**Indian Point Energy Center
Document Control
450 Broadway
Buchanan, NY 10511**

IPEC-EP 20-02, REVISION 27 & GR

Procedure/Document Number: IPEC Post Shutdown Emergency Plan	Revision: 20-02
Equipment/Facility/Other: Indian Point Energy Center (IPEC)	
Title: Indian Point Energy Center Emergency Plan

IPEC Emergency Plan Revision 20-02 (Rev 27 in eB) REVISION MATRIX

Figure 1.B-3

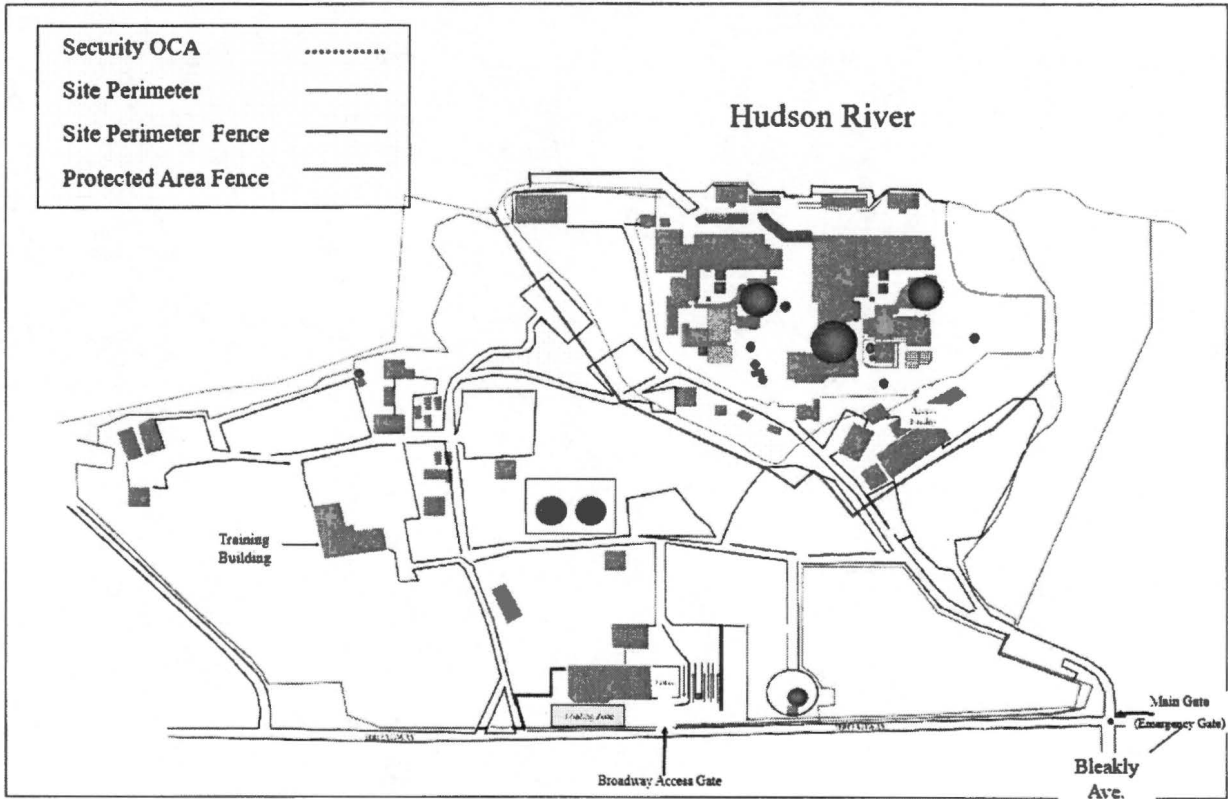
13.	Part 1 Page 9 Figure 1.B-3	Old map	Replaced with updated map	Yes	No – Replaced site map with updated version. There is no change to the content of the map. The meaning or intent of description in the emergency plan, facilities or equipment described in the emergency plan or a process described in the emergency plan are not affected by this change. No further evaluation is required for this change.

Figure B-1.1 Indian Point Energy Center Station Watch Organization per Unit

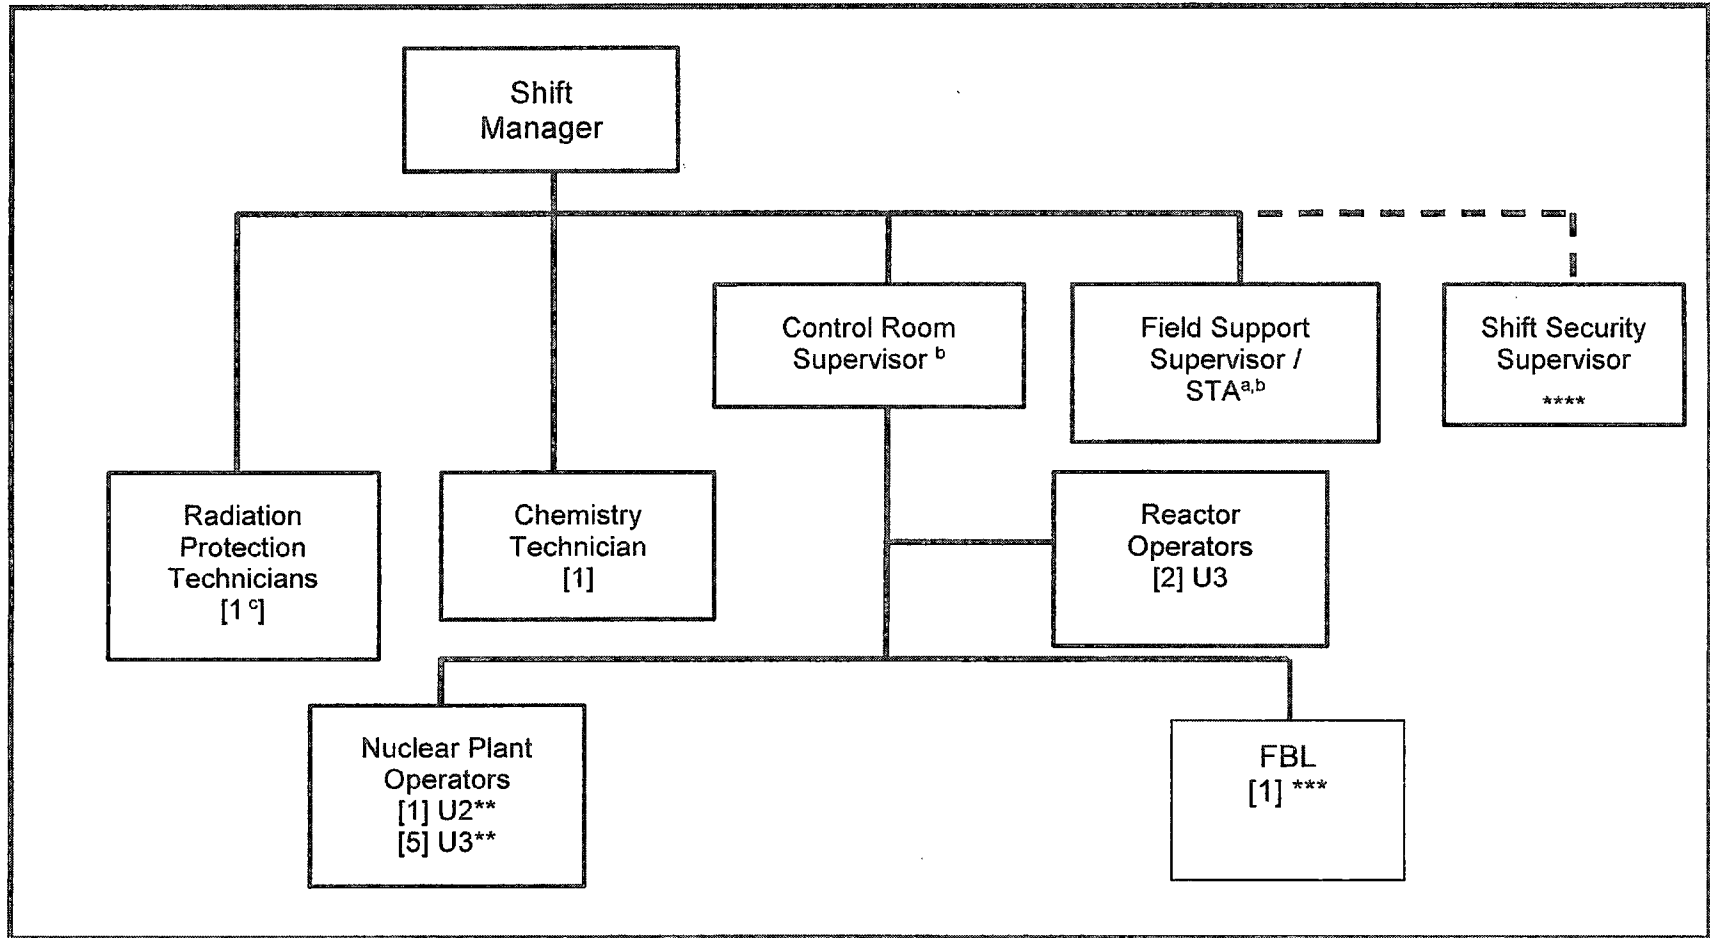
Change 9: This change added a foot note to clarify Shift Security Supervisor position is not per Unit but one position for the site. The meaning or intent of description in the emergency plan, facilities or equipment described in the emergency plan or a process described in the emergency plan are not affected by this change. No further evaluation is required for this change. This has been previously reviewed under 50.54q3 for EPLAN rev. 19-02.

9.	Section B Page B 12	N/A	**** Shift Security Supervisor position is a site position not per unit	No	<p>No-Added a foot note to clarify Shift Security Supervisor position is not per unit but 1 position for the site.</p> <p>The meaning or intent of description in the emergency plan, facilities or equipment described in the emergency plan or a process described in the emergency plan are not affected by this change. No further evaluation is required for this change. This has been previously reviewed under 50.54q3 for EPLAN Rev. 19-02.</p>

**** Shift Security Supervisor position is a site position not per unit

Figure B-1.2b Emergency Response Organization – Onsite

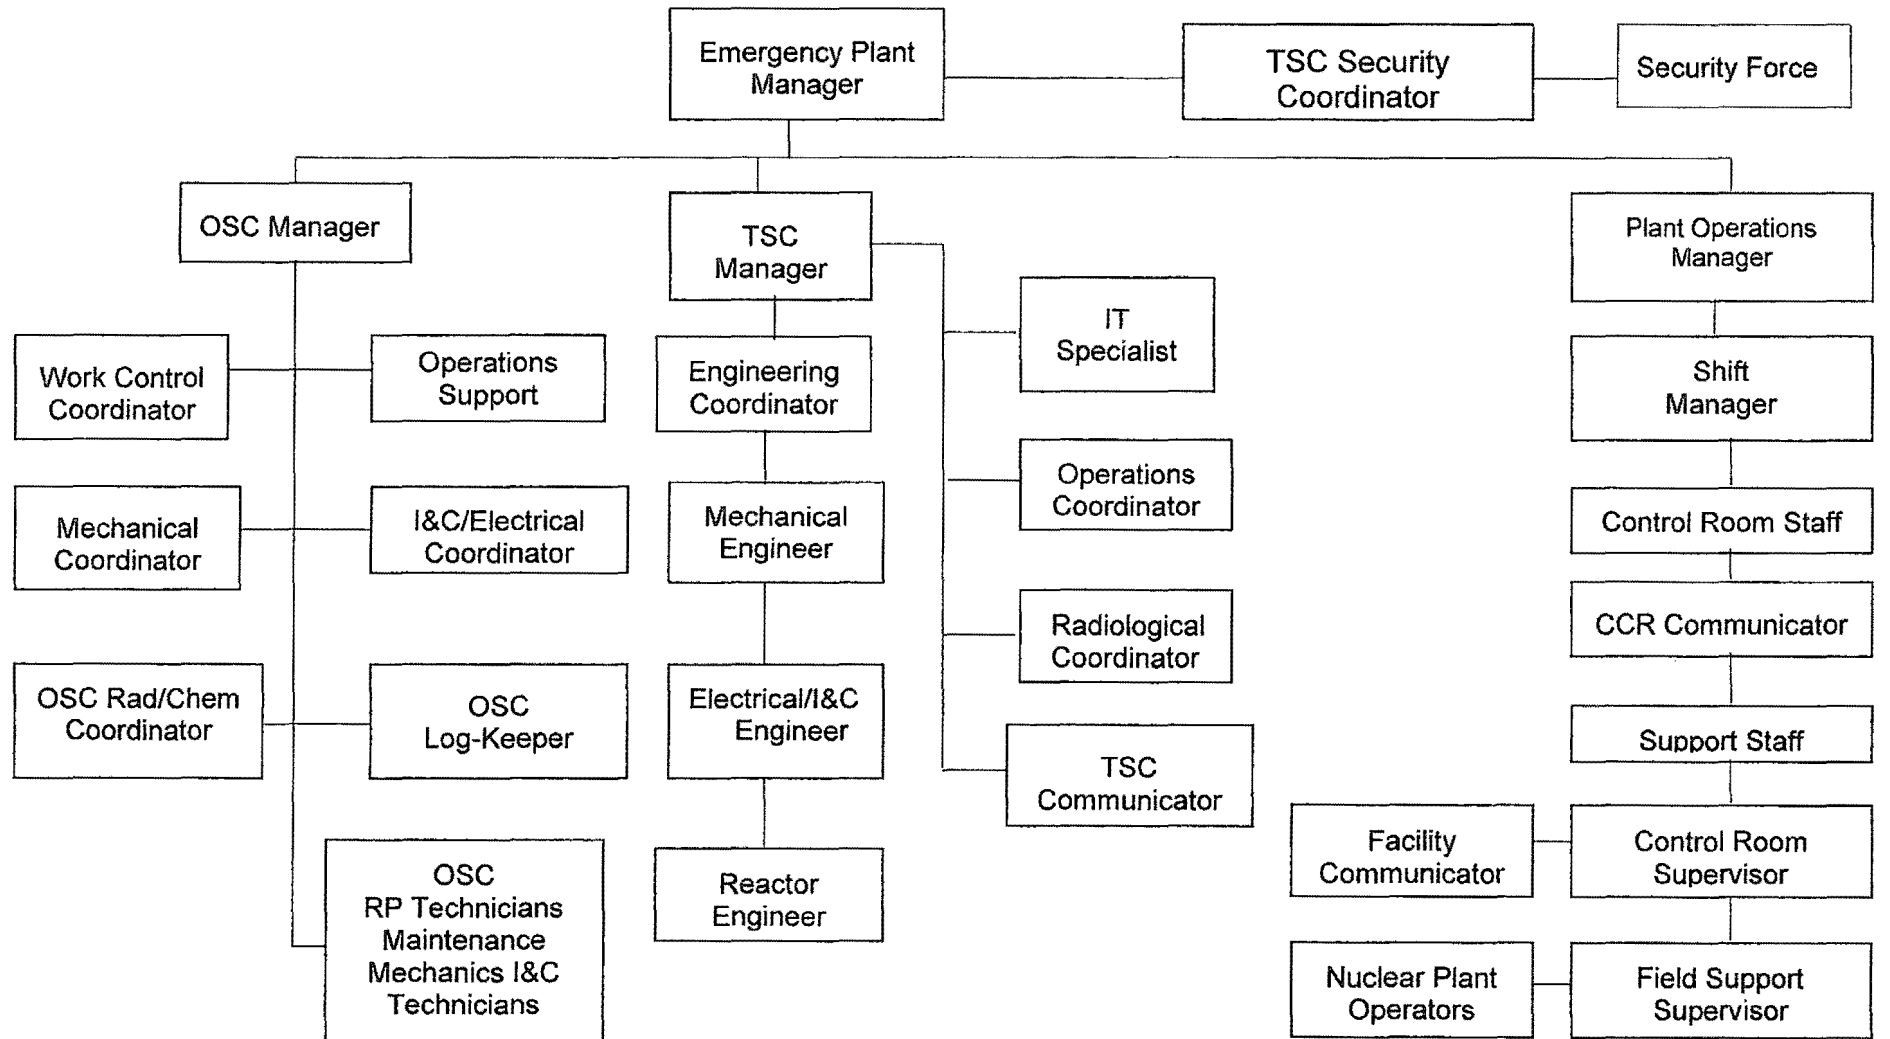
10.	Section B Page B 14	N/A	Inserted connecting line between TSC Manager and Engineering Coordinator	Yes	<p>No-The connection line was dropped from the previous revision. This was incorporated in EPLAN Rev.19-02.</p> <p>The meaning or intent of description in the emergency plan, facilities or equipment described in the emergency plan or a process described in the emergency plan are not affected by this change. No further evaluation is required for this change.</p>

11.	Figure B-1.2b Page B-14	An organization chart graphic line is missing that connects the Emergency Plant Manager to the TSC Manager and from the TSC Manager to the Engineering Coordinator.	These missing lines have been reinstalled.	Yes	<p>No – EPLAN Revision 19-03 clearly shows the correct organization lines connecting these positions. The lines were inadvertently removed in prior revisions and not shown in the PSEP as a carryover.</p> <p>The EPLAN Revision 19-03 remains valid and correct as the change was incorporated in EPLAN Rev.19-02.</p> <p>The meaning or intent of description in the emergency plan, facilities or equipment described in the emergency plan or a process described in the emergency plan are not affected by this change. No further evaluation is required for this change.</p>
